VERIFICATION /
CERTIFICATION REPORT

INNER MONGOLIA XIMENG
ZHELIGENTU WIND FARM
PHASE I PROJECT
IN CHINA

Verification Period:
1 May 2009 to 5 May 2010

REPORT No. 2011-9383
REVISION No. 01

Figure 1: Simplified Power Grid Connection Diagram

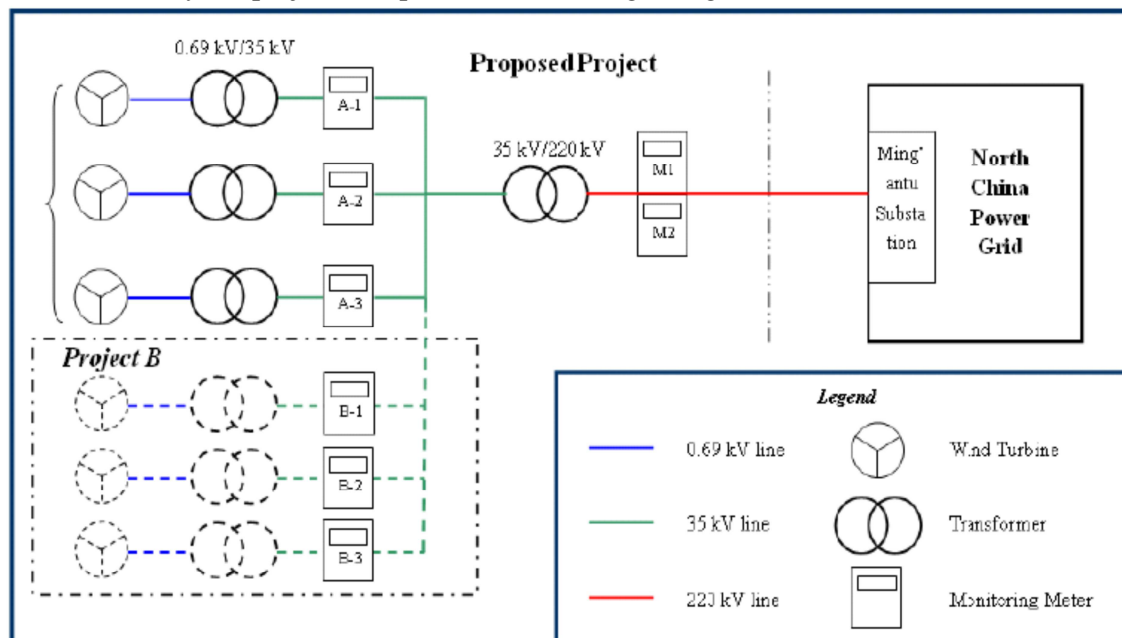
The 39 sets of wind turbines were divided into 3 groups, and each group is connected with a 35kV transmission line and installed with a meter at the low voltage side of 35kV/220kV transformer. Three meters A-1 (SN:9030094), A-2 (SN:9030093), A-3 (SN:9030096) were separately installed at lower voltage side of three 35kV/220kV transformer of Inner Mongolia Ximeng Zheligentu Wind Farm Phase I Project so as to monitor the electricity supplied by the proposed project; and another three meters B-1 (SN:9030087), B-2 (SN:0010037), B-3 (SN:0010038) were separately installed at lower voltage side of three 35kV/220kV transformer of Inner Mongolia Jingneng Zheligentu Wind Farm Phase II Project to monitor the its electricity the project B exported, as following in Figure 1.

Above all, it was confirmed by DNV that the project has been implemented in accordance with the design mentioned in the registered CDM PDD /1/, revised CDM MP /3/.
